MINOR PROJECT MODIFICATION

SAN FRANCISCO PUBLIC UTILITIES COMMISSION WATER SYSTEM IMPROVEMENT PROGRAM

Minor Project Modification Number: 001		Date: 5/16/11
Project Title:	Calaveras Dam Replacement Project	
MEA Case No./Project No.	2005.0161E/CUW37401	
MPM Prepared By:	Booker Holton, ECM	
MPM Triggered By:	<input type="checkbox"/> RFD <input type="checkbox"/> PCO <input checked="" type="checkbox"/> Other: SFPUC	
Landowner:	SFPUC	East Bay Regional Park District & Garcia Resident
Vegetative Cover/Land Use:	Landscaped, paved, gravel areas; bare soil, disturbed grassland	Net Acreage Affected: 0.005 acre (200 sq. ft.)
Modification to:	<input type="checkbox"/> Mitigation Measure:	<input checked="" type="checkbox"/> Other: Project Design
	<input type="checkbox"/> Permit:

Figure 5
Changes to Dam Access Road

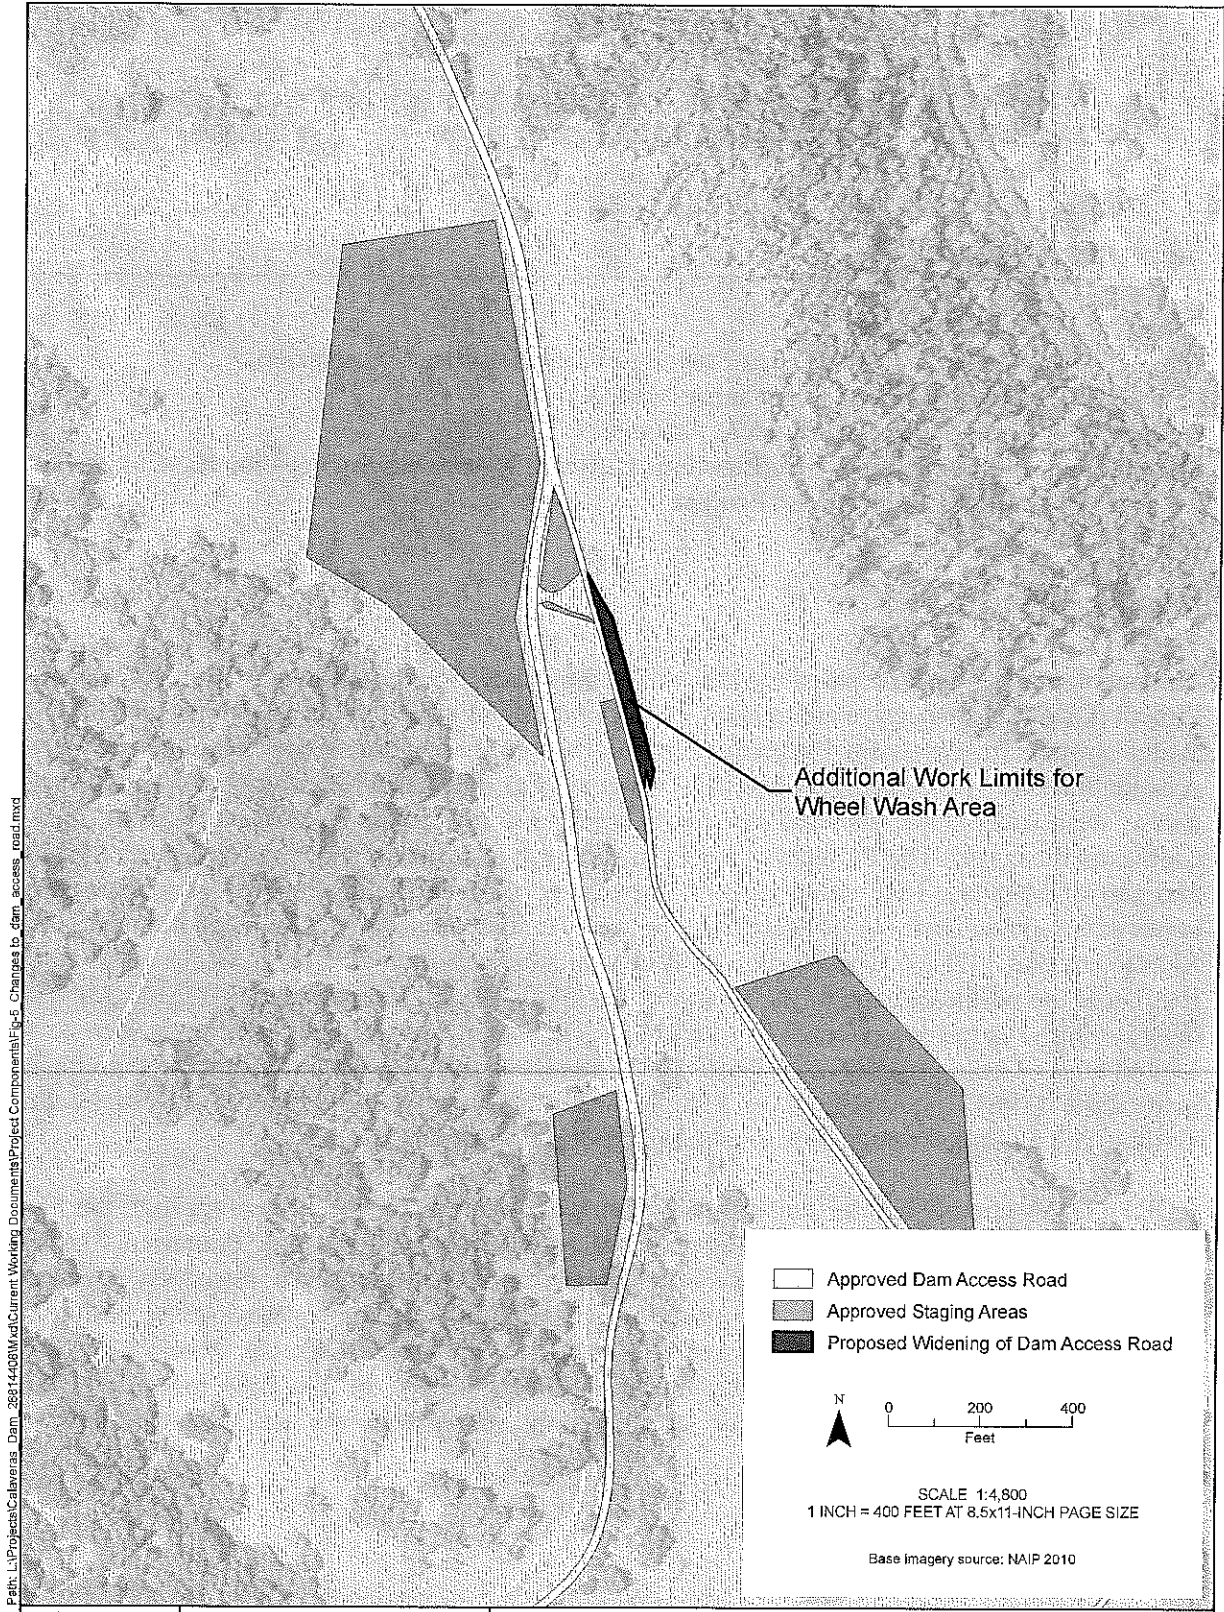
The contractor is requesting a minor road at the Calaveras Dam Replacement Project (CDRP) along the dam access road to accommodate a project-required vehicle wheel wash and maintain two-way traffic lane for large construction vehicles entering and exiting the site (Attachment A-Figure 5). Installing a wheel wash in this location will allow the contractor to wash exiting and entering construction vehicles per the project Asbestos Dust Mitigation Plan, per the contractor's Storm Water Pollution Prevention Plan, and per invasive species eradication measures for restoration.

Figure 3
Changes to Disposal Site 7 Haul Route

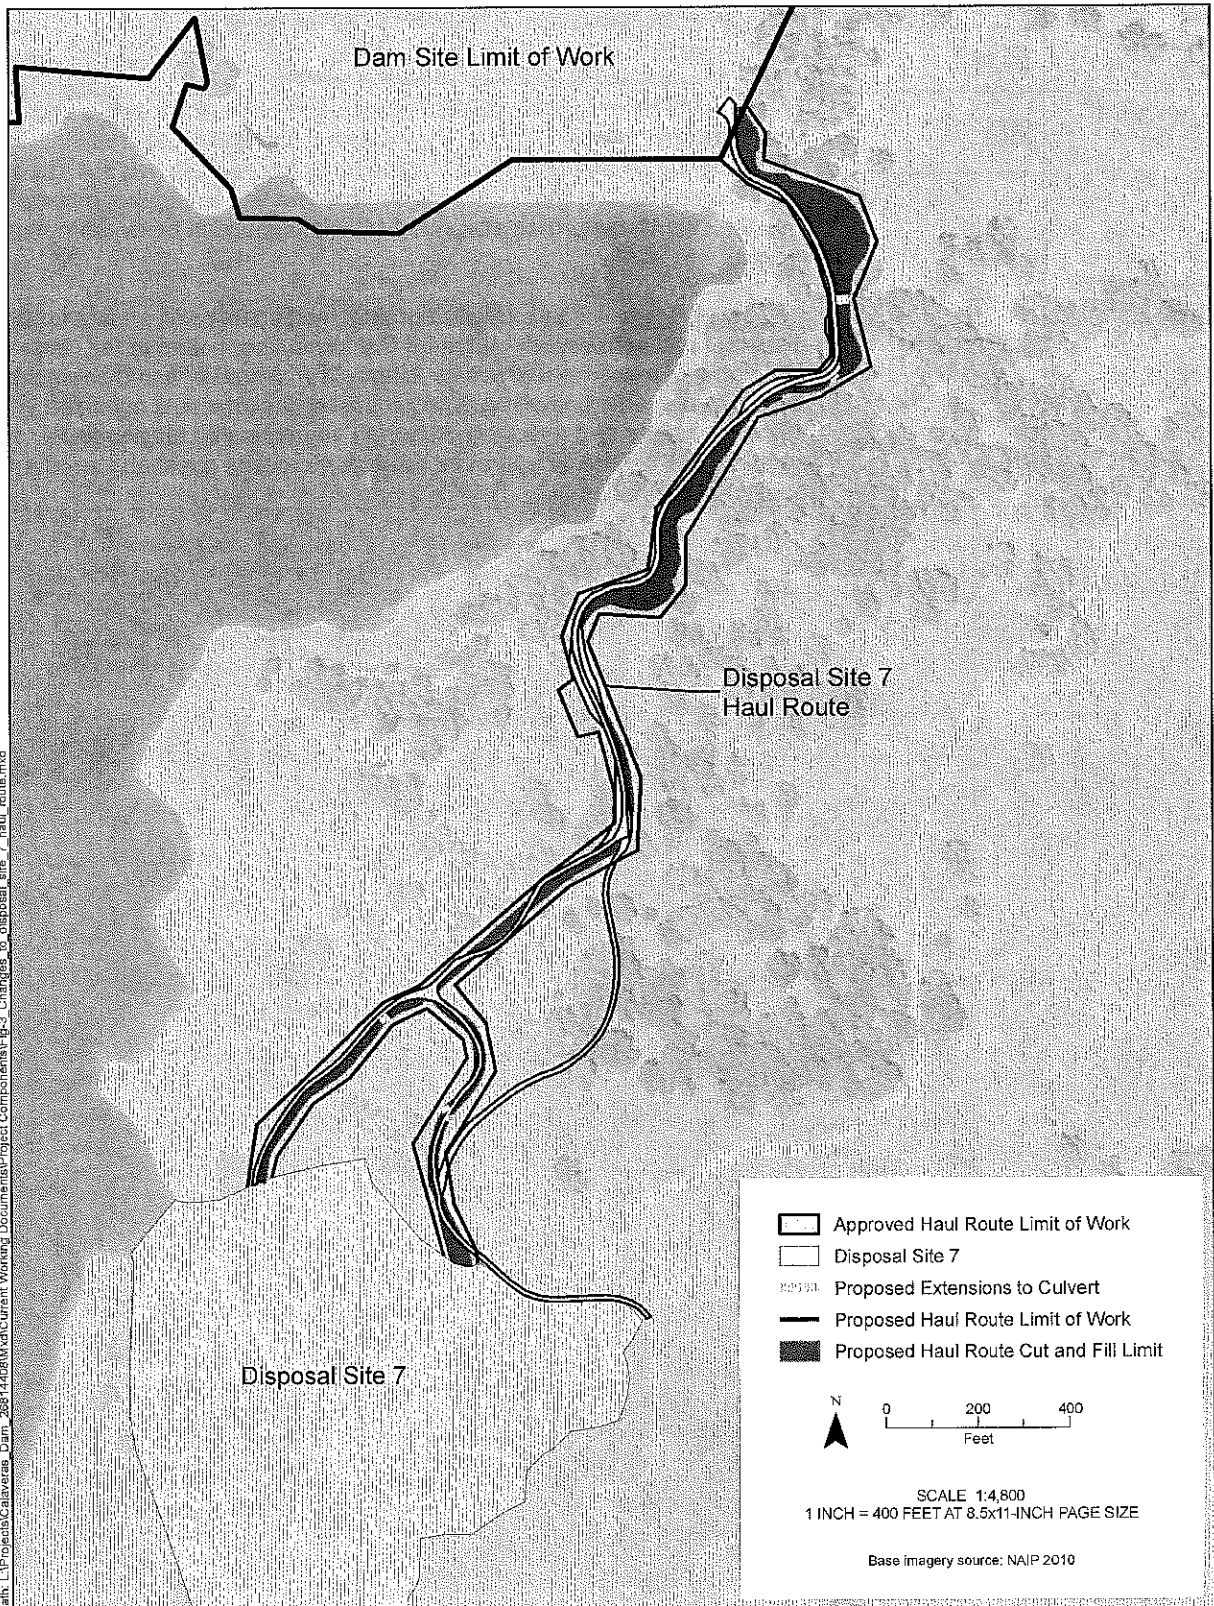
The SFPUC requests a minor site expansion at the Calaveras Dam Replacement Project (CDRP). Due to safety concerns and the size of the vehicles that will be used to place material in Disposal Site 7 (DS7), the haul route will need to be widened (Figure 3). The approximately 1 mile long approved haul route will utilize an existing dirt and gravel road on the northeast side of the reservoir, which crosses three minor drainages. The original design restricts work limits to the existing road width. However, portions of the road show signs of tension cracking, which indicate a safety hazard: the haul trucks would be forced to drive near the outside curb in the cracked areas and could initiate slope failure due to overload. Road widening and cutting will remove this hazard. The required cut and fill will impact 2.55 acres of diablan scrub, oak woodland and non-native grassland for construction access. Road widening would require temporary extension of existing culverts where the haul route crosses three drainages and along the entire length of the DS7 haul road.

Figure 4
Changes to Borrow Area B and Right Abutment Road

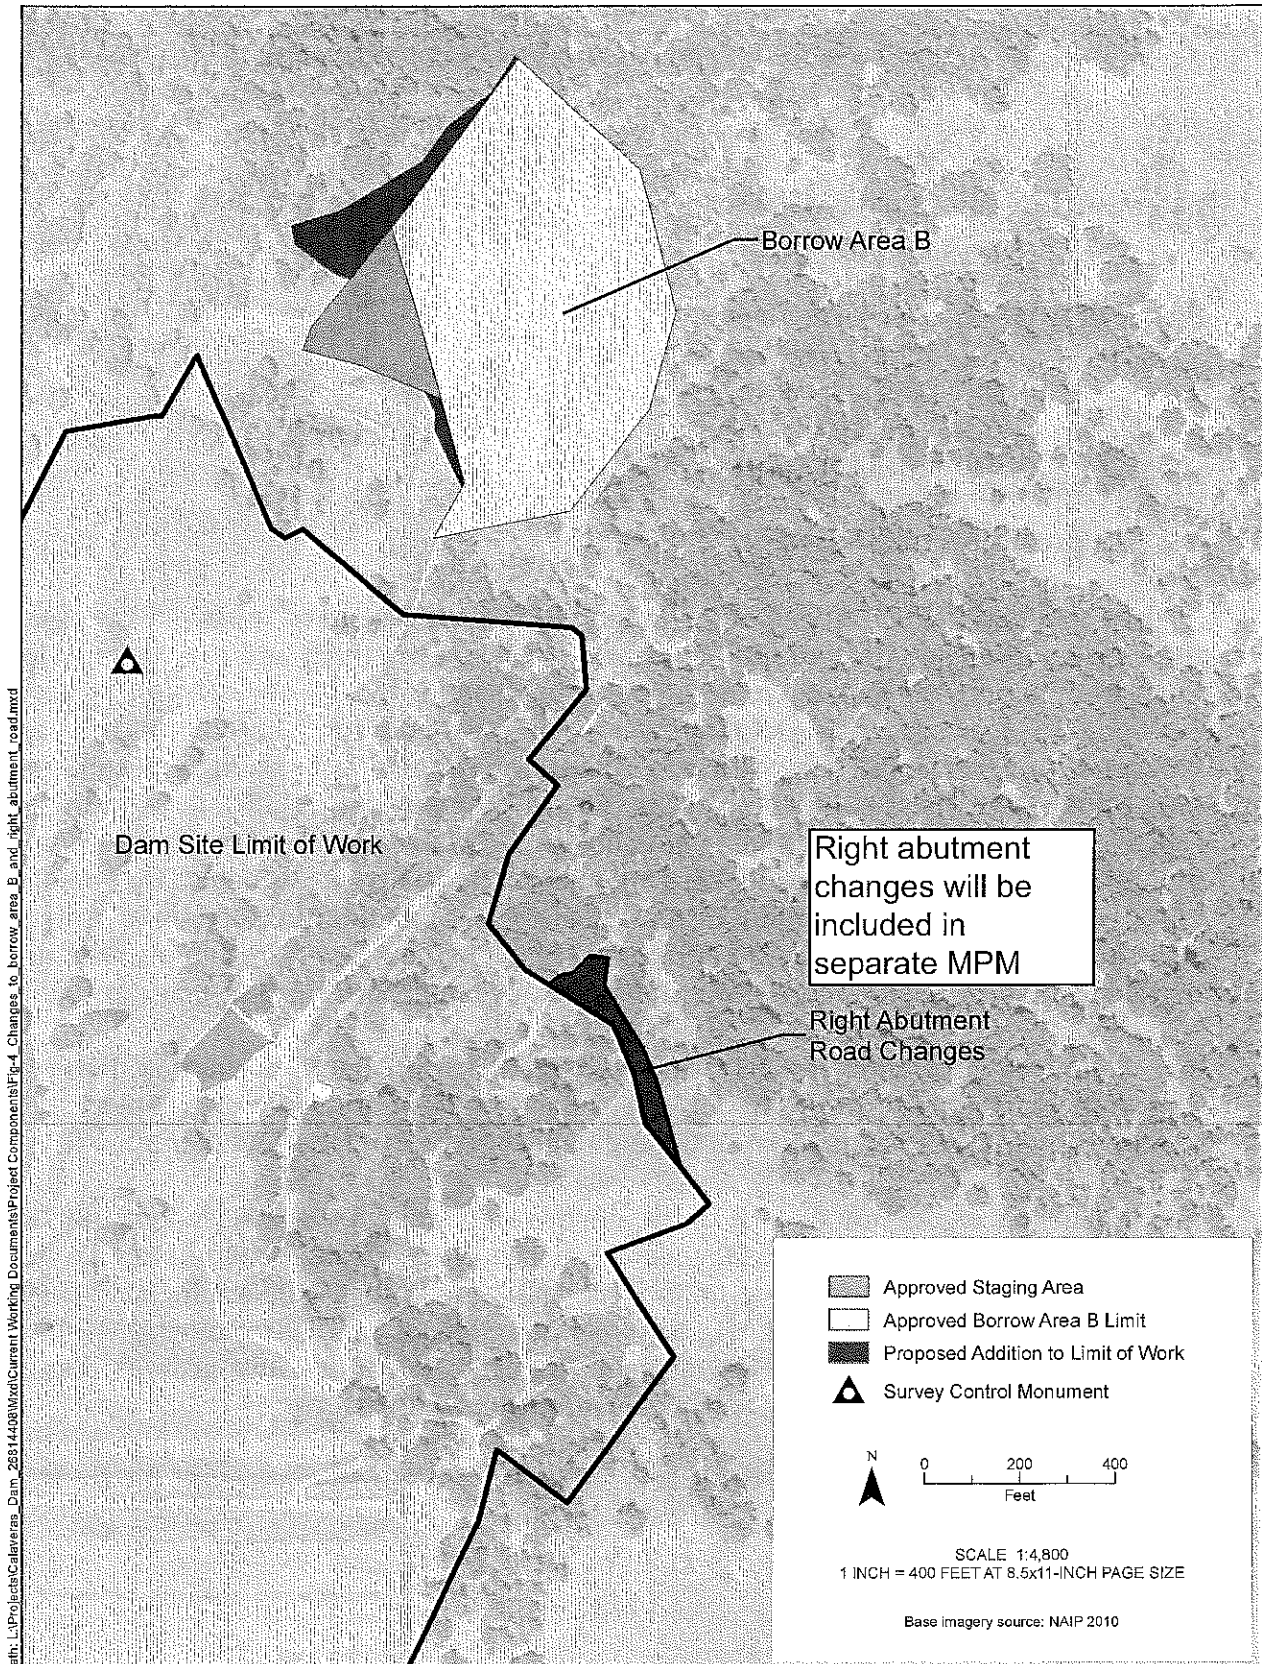
The Contractor is requesting a minor site expansion at the Calaveras Dam Replacement Project (CDRP) in order to facilitate a safe, stable and successful slope restoration effort. The expansion area, which is located adjacent to Borrow Area B (BA-B), would be used to "lay-back the slope" for stability reasons while mining for the rock material for Dam construction begins. The proposed minor expansion would undergo final grading and contouring prior to the 2012 winter season. Figure 1 depicts the proposed grading plan for BA-B and the expansion area.

Figure 1. CDRP- Location of Minor Project Modification at Staging Area 6 and Reduction of Project Footprint in Staging Area 3

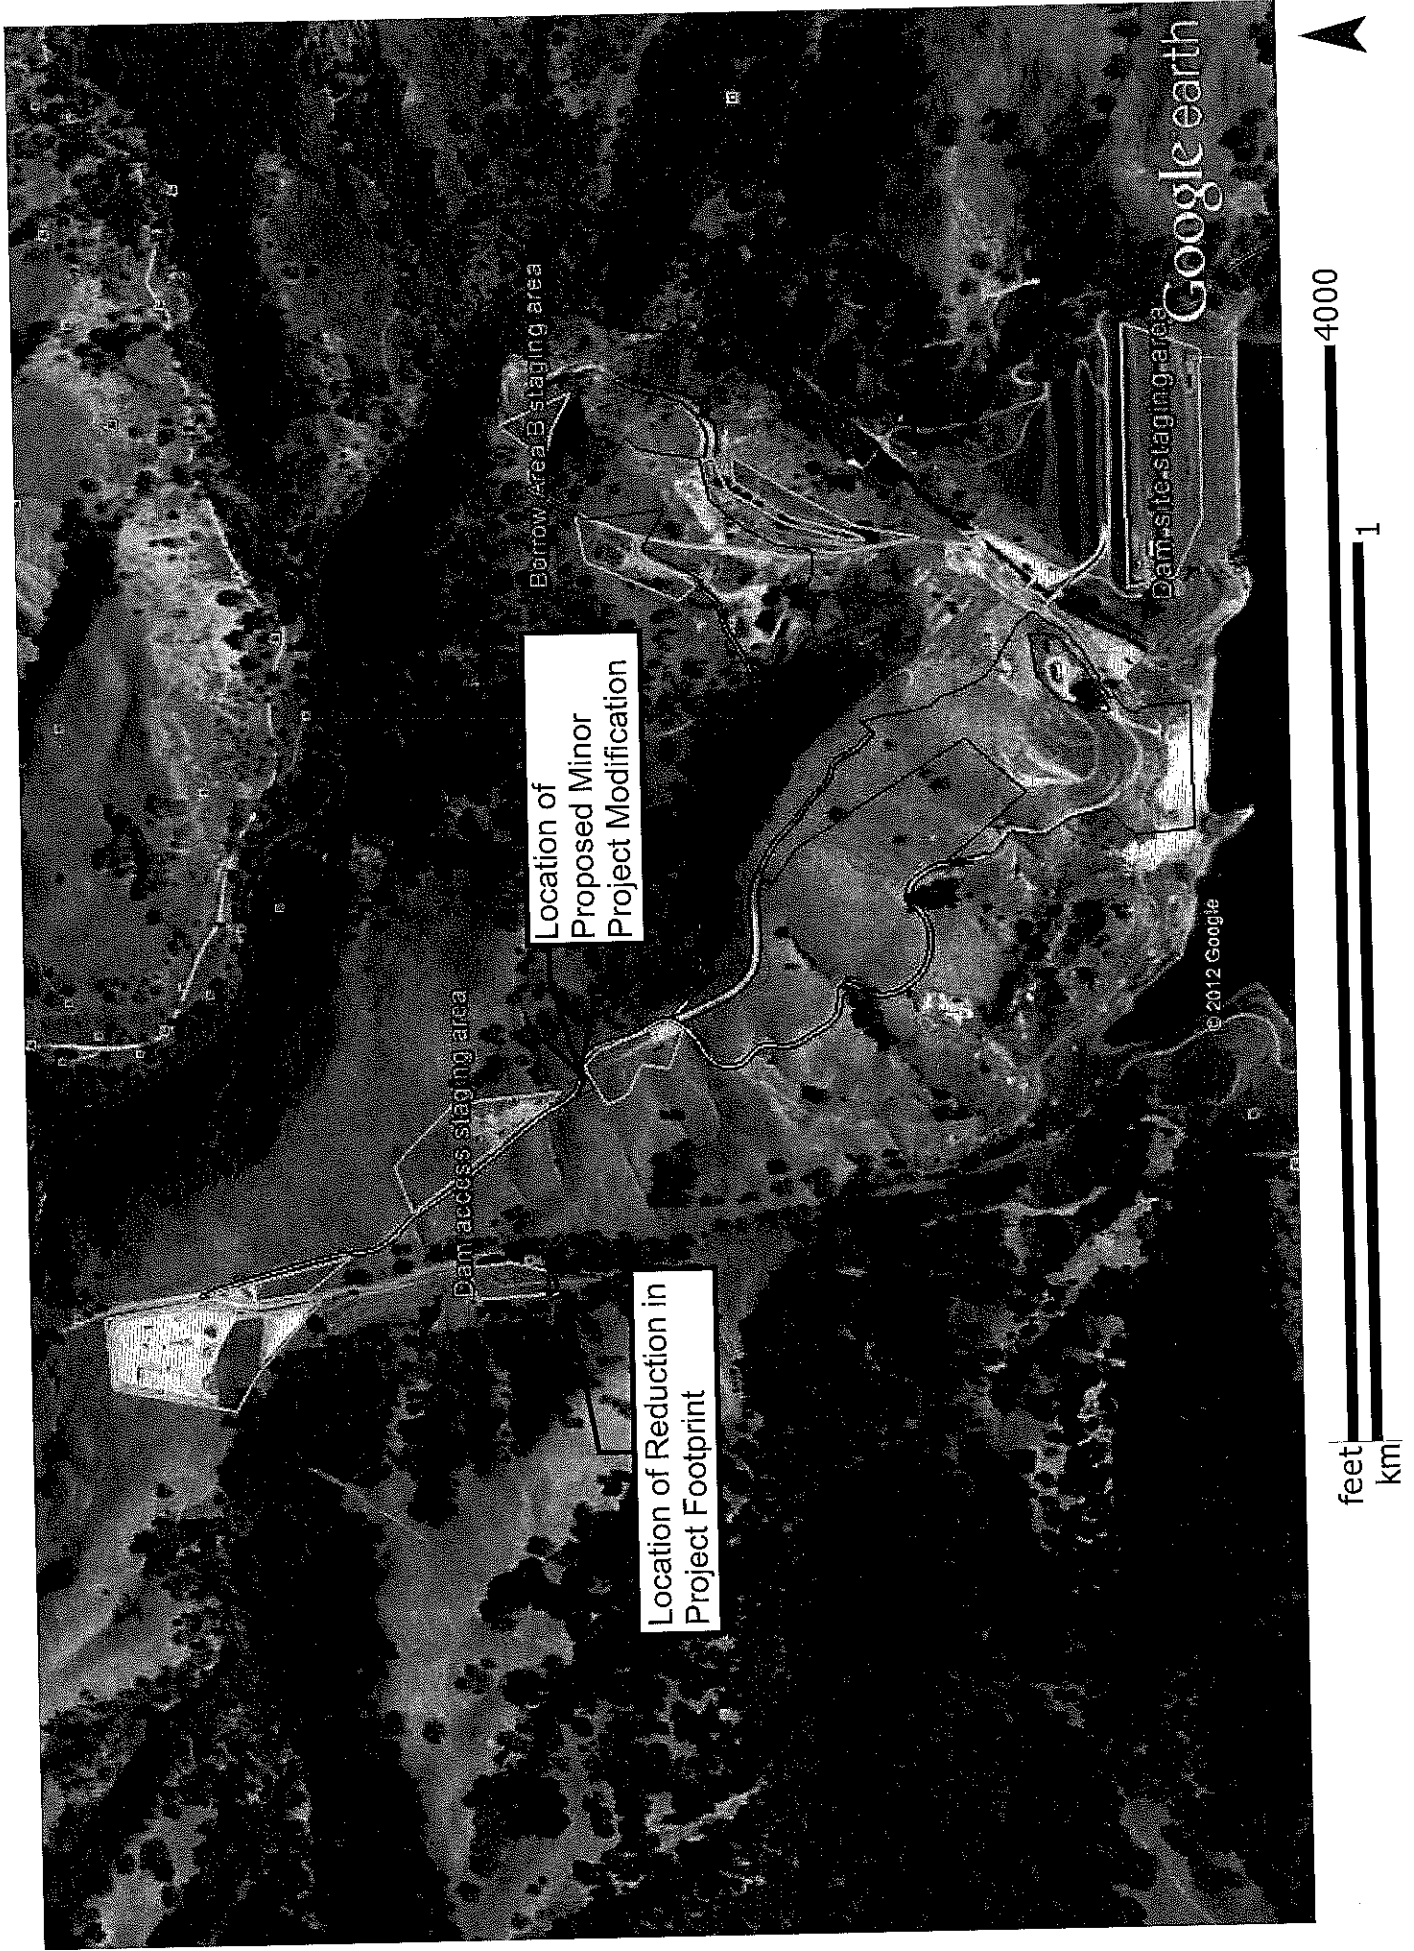
The Contractor is requesting a minor project modification (MPM) to Staging Area 6 of the Calaveras Dam Replacement Project (Figure 1). This Staging Area is the only available location for parking vehicles within the project's main gate that will be free of naturally occurring asbestos. Staging Area 4 is being used to stage the Batch Plant and Maintenance and Fueling Facility. Logistically it is important to have workers able to enter the front gate security prior to start of the work day.
